Early Design Guidance 2
8.28.2019
3033617-EG
725 Yesler Way

SECTION 03 / EDG-1 Summary of Board Guidance

Summary of Board Guidance

View From Yesler Terrace Park

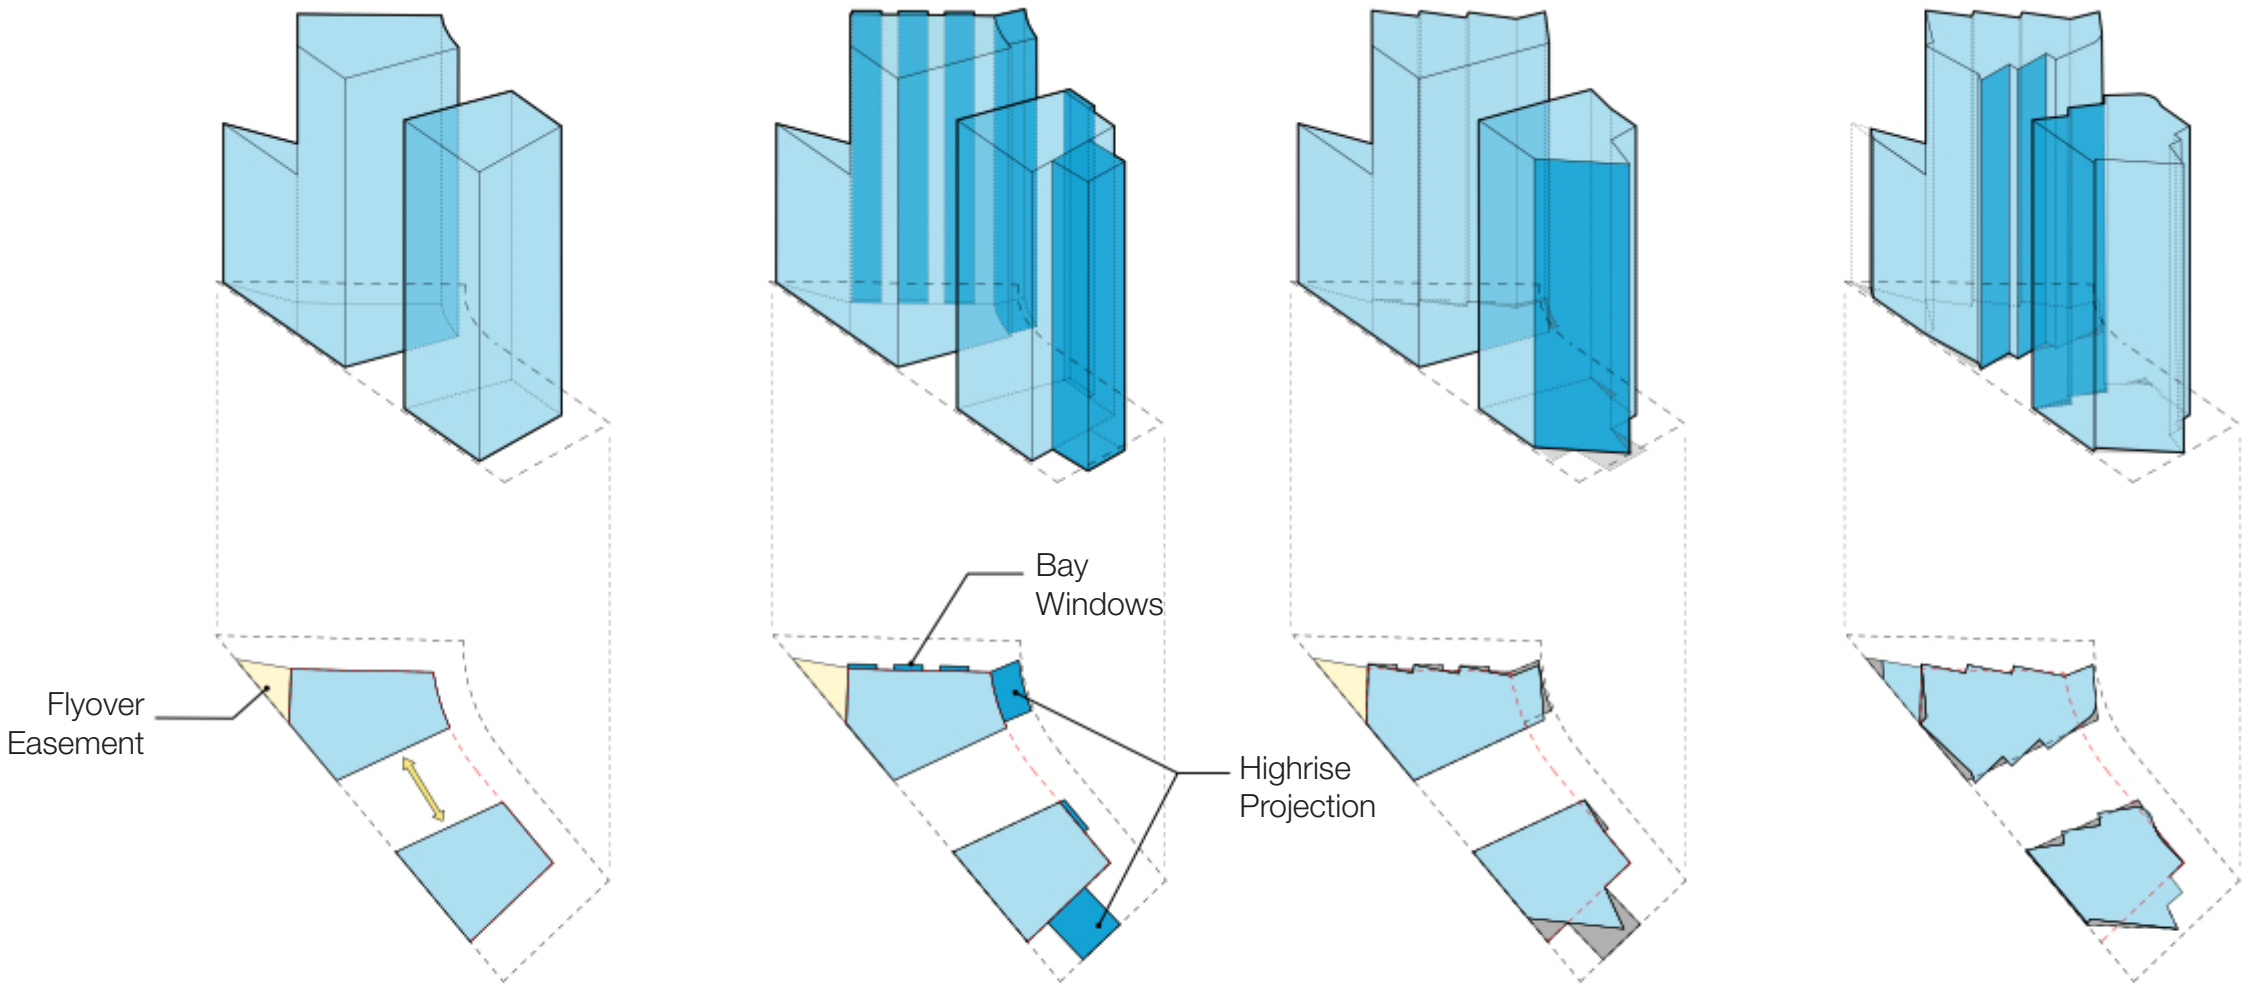
While the Board supported the bold design, they would like to see further illustration of how the unusual and varied tower plans were designed to respond to various views, and if there was a conceptual framework for how the shapes were generated.

The Board discussed how to achieve a greater sense of clarity with the treatment of the tower facades to achieve a more coherent design, for example how to reconcile curving shapes, angled surfaces and sawtooth faces, while acknowledging the faces to the city and the park may be different. The Board requested clarification if the sawtooth expression is intended to occur at the podium as a smaller scale element.

The sculptural tower forms have been generated by responding to view from the surrounding context, as well as the configuration of interior spaces to create a dynamic addition to Seattle’s skyline. From I-5 and views from the west, the towers massing is divided into large simple planar elements which have a clarity of form from a distance and while traveling at high speed along the freeway. The long north and south facades of the North Tower, and the north façade of the South Tower, are divided into angular bay windows creating a smaller scale. These give each apartment a view to the west and develop a directional grain to the towers as a whole. At the north podium sawtooth windows continue the language established by the towers. From the park the tower profiles curve into the central space creating a welcoming gesture to reinforce the open podium concept.

While the language of the formal moves vary, careful transitions between each façade, and the of the development window wall composition will unify the design.

Phase 1 + 2 Views

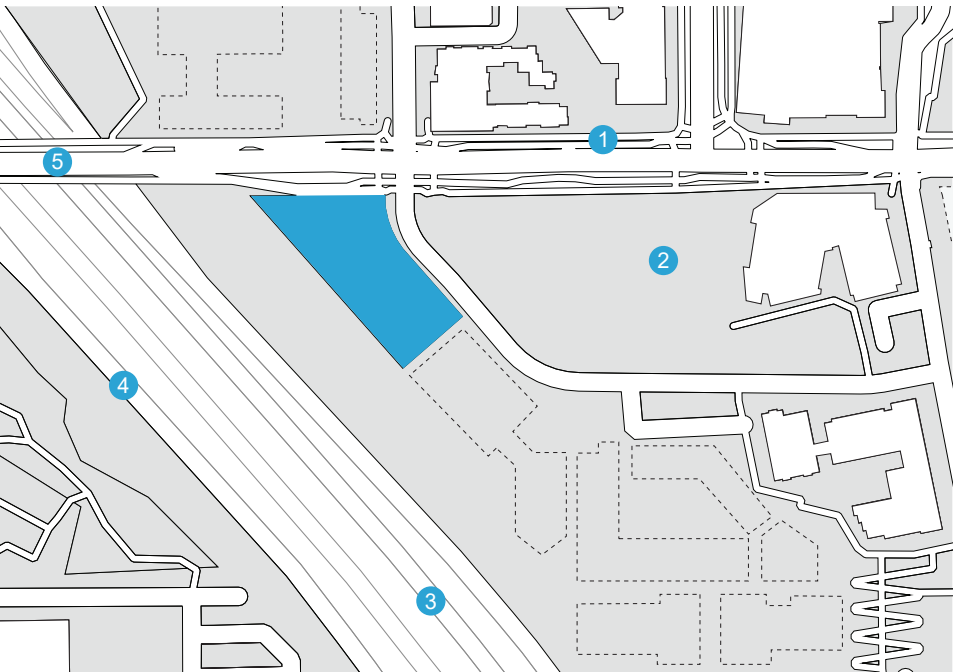
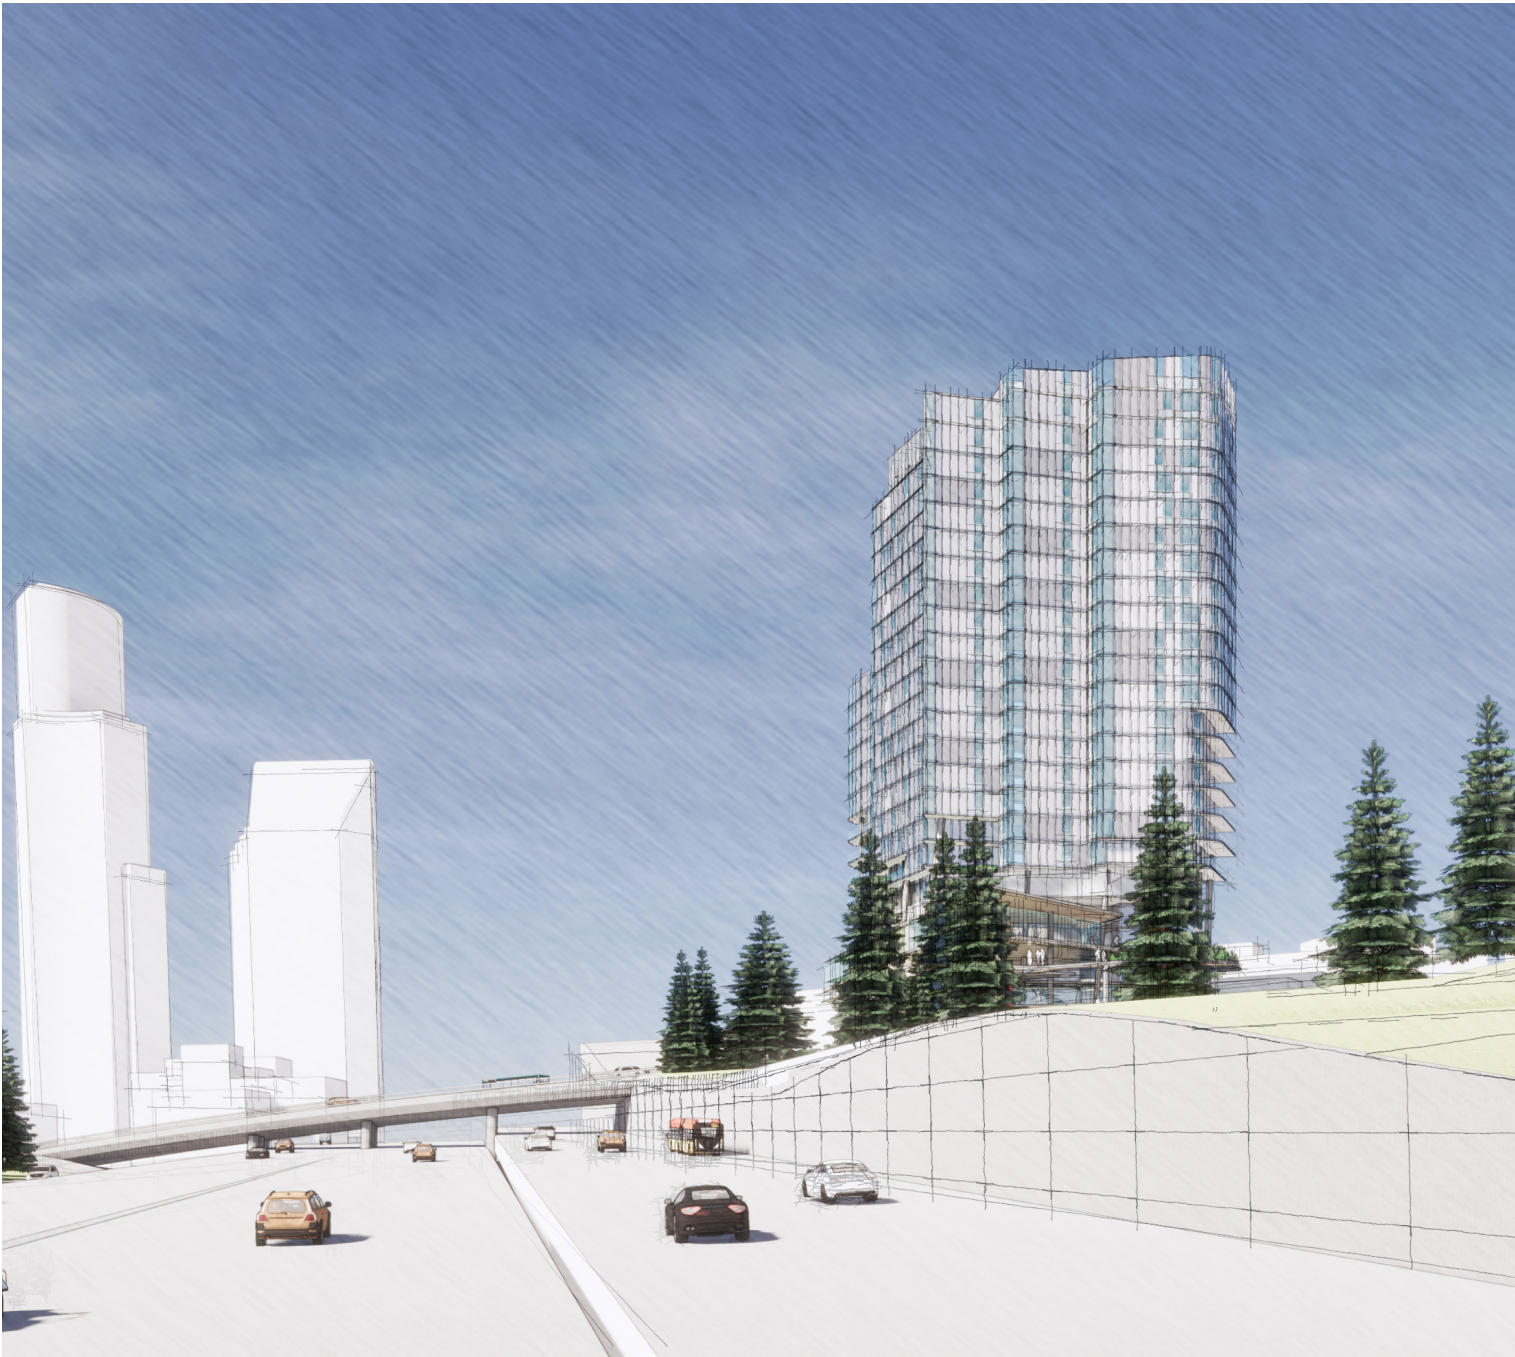
The Board requested renderings of the Phase 1 tower alone, particularly the view from I-5 northbound, to understand how the project would create an effectively iconic form and meets the Design Guidelines if Phase 2 is not completed.

The standalone Phase 1 tower form responds to views from I-5 northbound with a saw-toothed expression breaking up the scale of the wide façade. The gently sloping rooftop feature rises up toward the park, creating a slender dramatic prow facing westbound Yesler Way. From downtown, the tower is broken into two large planes, slightly offset to reduce their scale, and emphasize their verticality. A lower wedge-shaped volume below the flyover steps the scale down to the street.

Tower Massing Toward Yesler Terrace Park

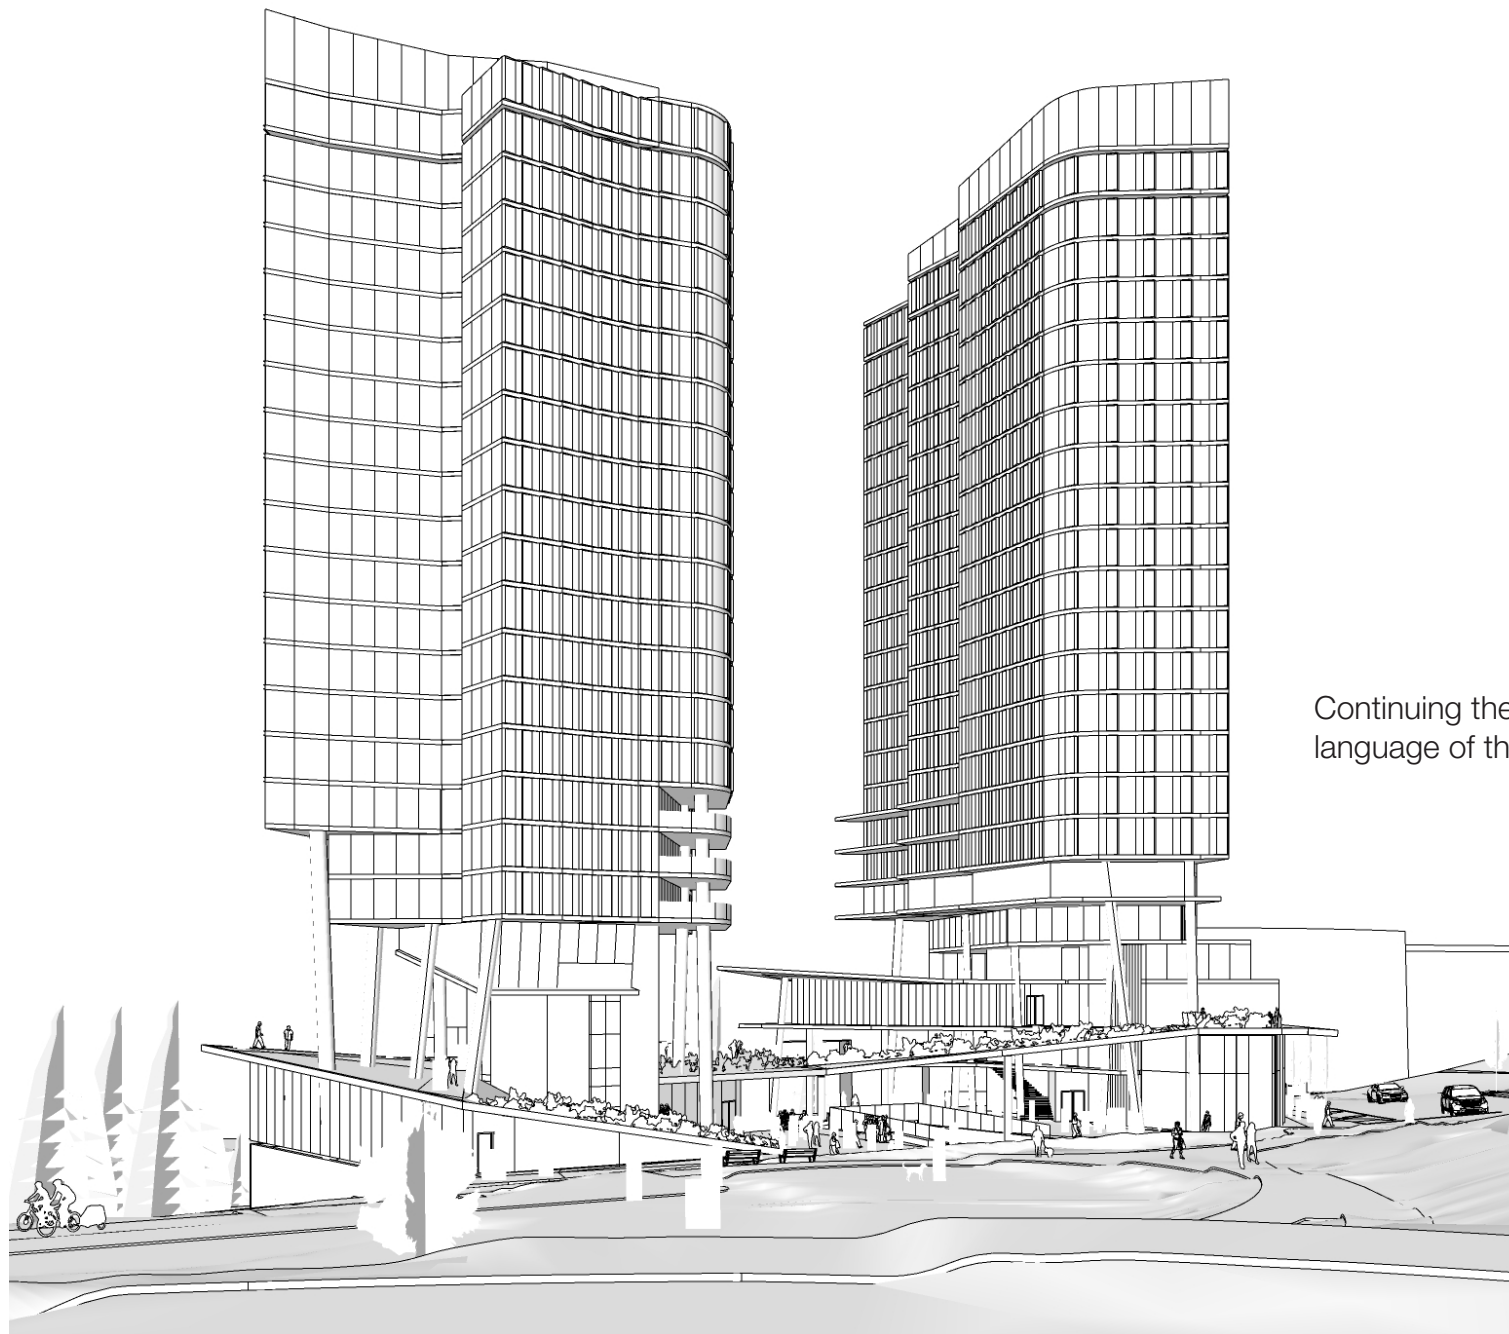
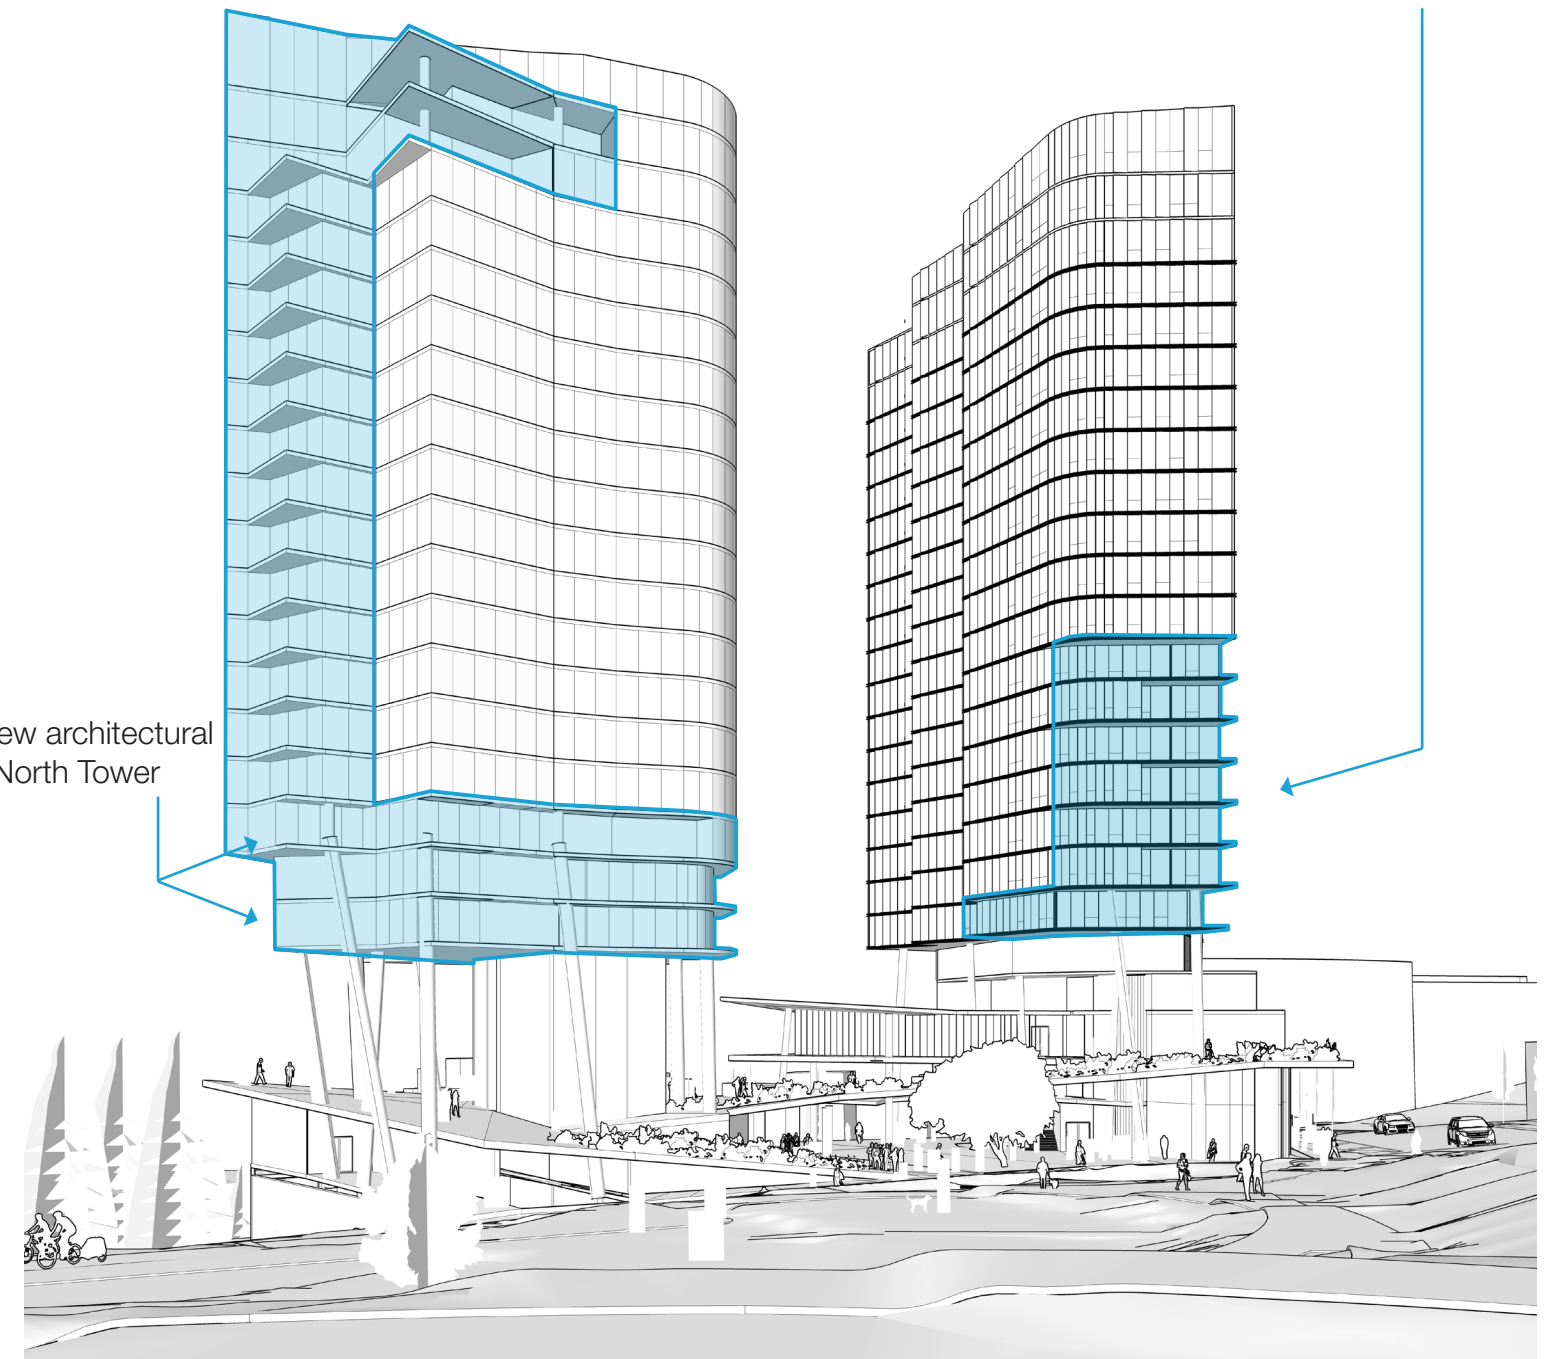
The Board supported the curving tower forms facing Yesler Terrace park as a welcoming gesture but noted there could also be opportunity for a mid-height gesture facing the park.

Additional balconies facing the park help to reinforce the architectural concept of creating a pedestrian oriented environment at the podium by extending the scale and openness into the towers. The balconies help to break the large tower mass into parts, without compromising the large gestures supported by the board.

Breaking down the facade for a mid-height gesture facing the park and adding balconies
